| TECHNICAL NOTE |                                                                                                         |           |  |
| subject:       | <b>Application for reserved matters consent (appearance, scale, landscaping and layout) 3/2021/0556</b> | file ref: | J1401-TN1                                                                           |

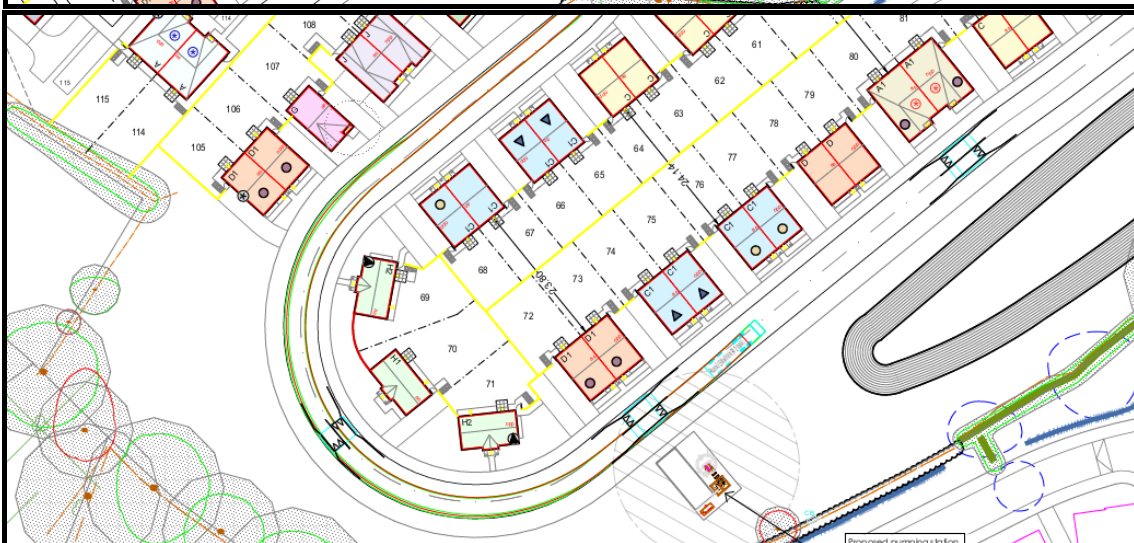
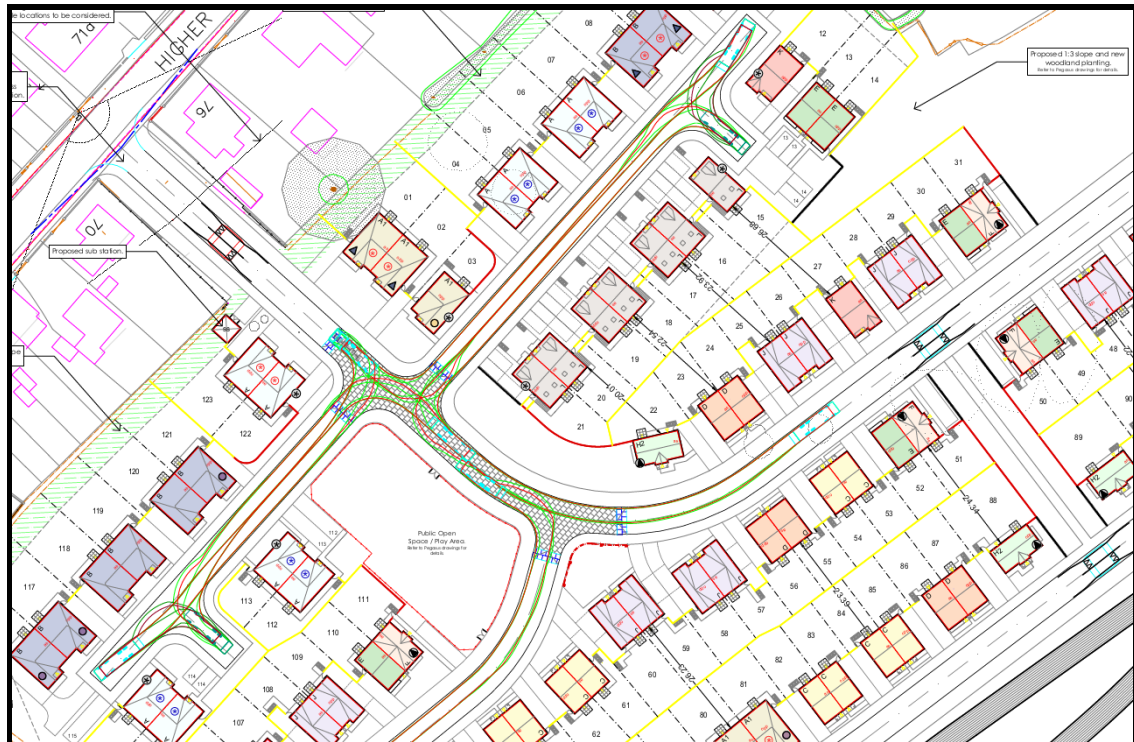
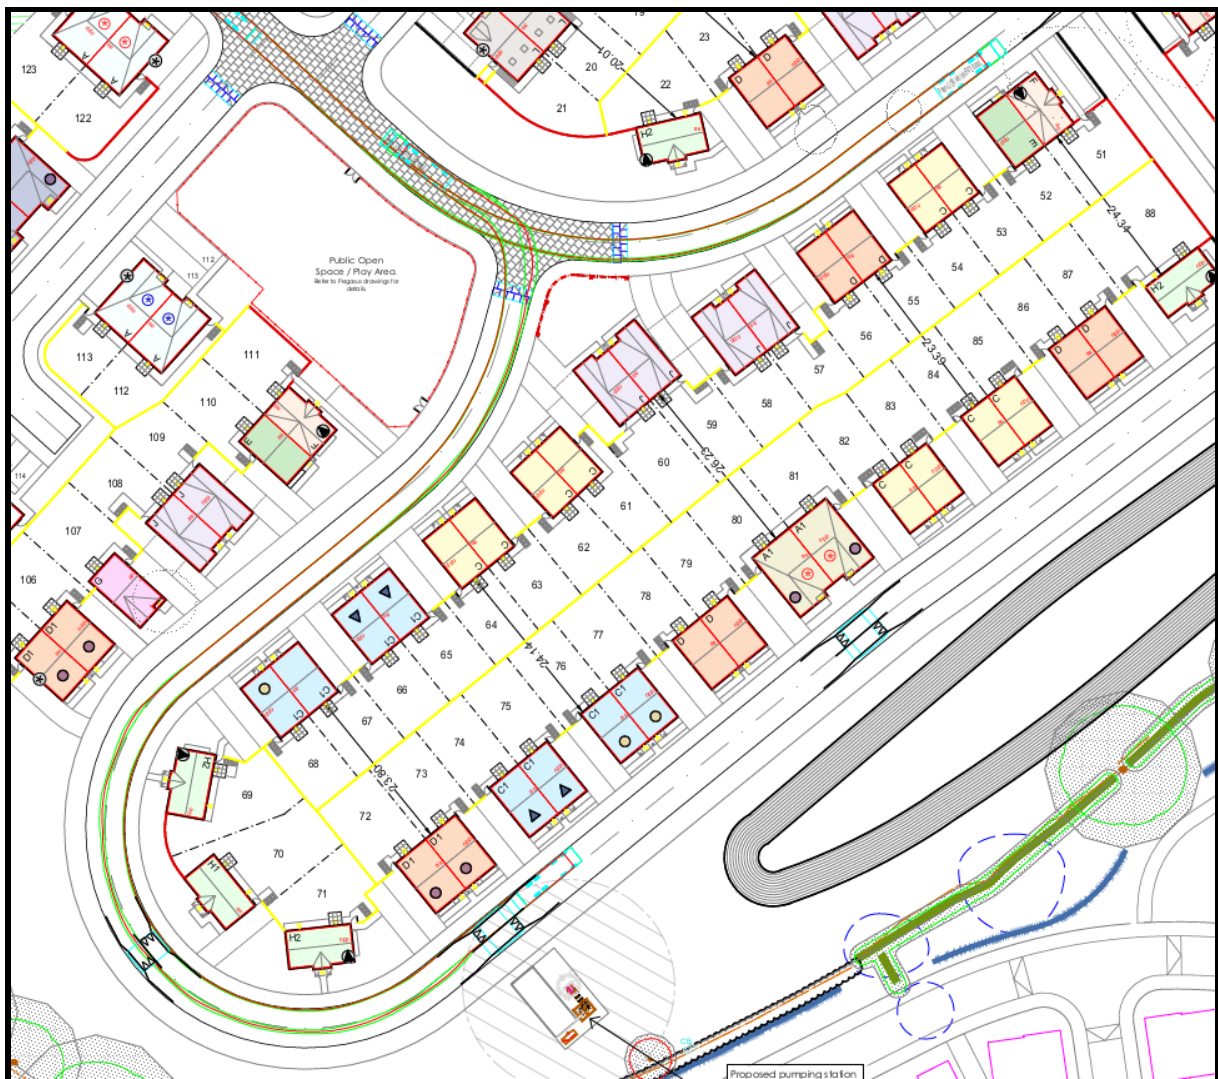
*to further support the width of the carriageway, the LHA require a swept path analysis drawing to be submitted to the LHA, showing that the carriageway is usable for large, refuse vehicles.*

*The swept path drawing should also show refuse vehicles using the turning heads which are provided at the site.*

**Figs 3 and 4 provide the swept paths, fig 3 assumes a clockwise movement of in then cul de sac to north side, running around site and bend to east side, around southerly edge to bend and then vis junction to turning head on left side before exiting.**

**For completion fig 4 shows the internal junction and the bends in the anticlockwise direction.**

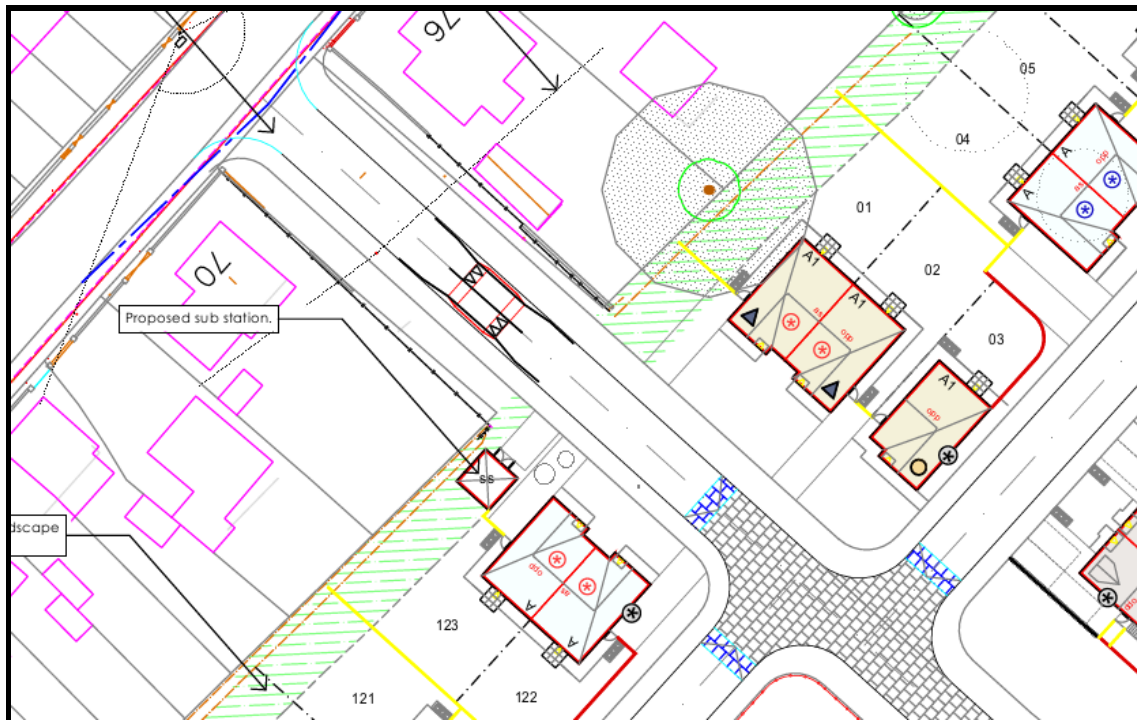
While the LHA understands that the Applicant has proposed some speed control measures, as shown on the drawing, there are large, straight sections along the road network which do not have any speed control measures in place. Therefore, to ensure traffic does not exceed the speed limit in these locations, a form of speed control measures/ traffic calming need to be introduced for the entirety of the site.

The LHA reminds the Applicant that the distance between each speed control measure should not exceed 80m.

**Flat topped humps have been used except for a round topped hump for the westerly mid bend. None exceed 80m between features.**

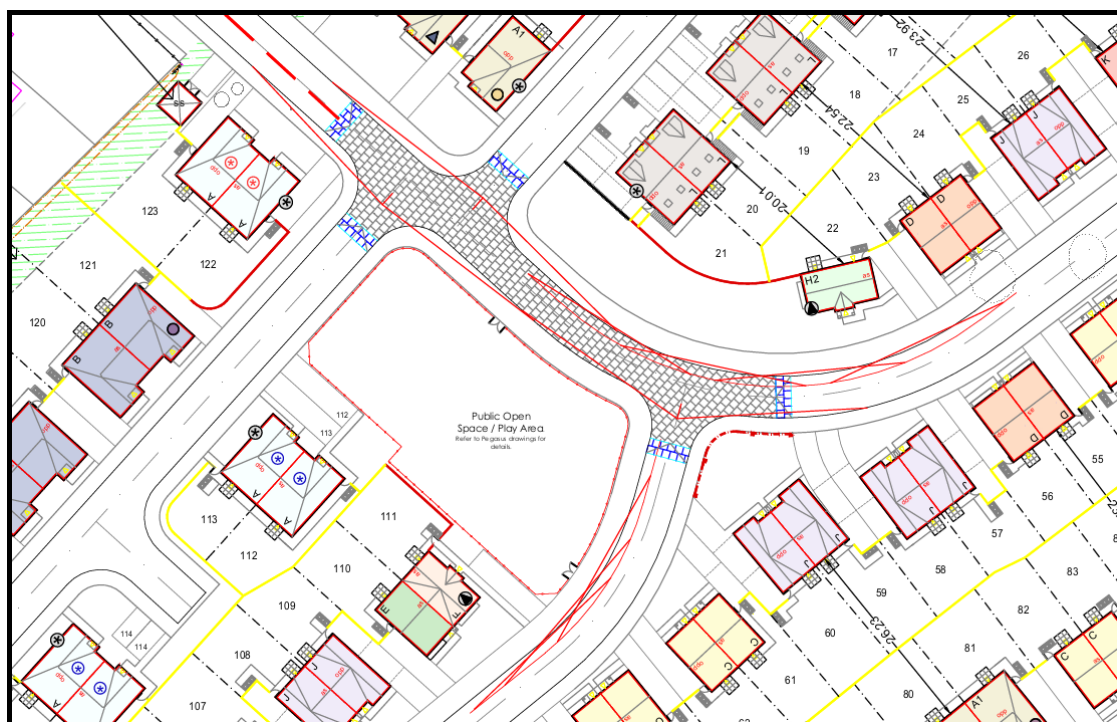
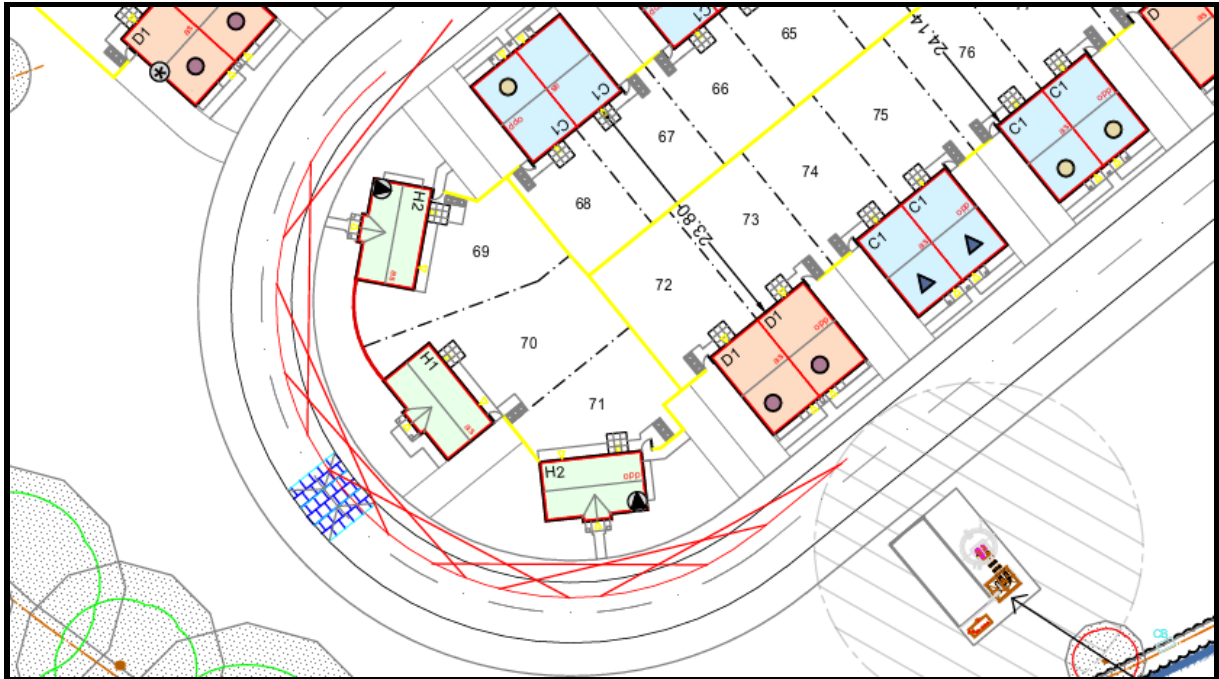
The LHA require vehicular visibility splays of 2m x 25m to be provided on a scaled drawing at the junctions along the highway network. This is to ensure that minimum vehicular visibility is possible in these locations. Not only this but the LHA require vehicular visibility splay drawings to also be shown around the curves in the road to ensure that vehicles are able to view others where the gradient at the site, is at its steepest. These splays will also show that there is nothing obstructing vehicular visibility in these locations.

Fig 1 shows the junction sight lines of 2.4\*25m for a 20mph road with calming. In addition bends have been assessed for the mid line forward visibility as shown again for 25m. with the exception of the eastern bend all areas have the forward sight line within the footpath width.

The easterly bend shows overlap into garden area requiring a condition to say no plants etc over 0.6m in height.
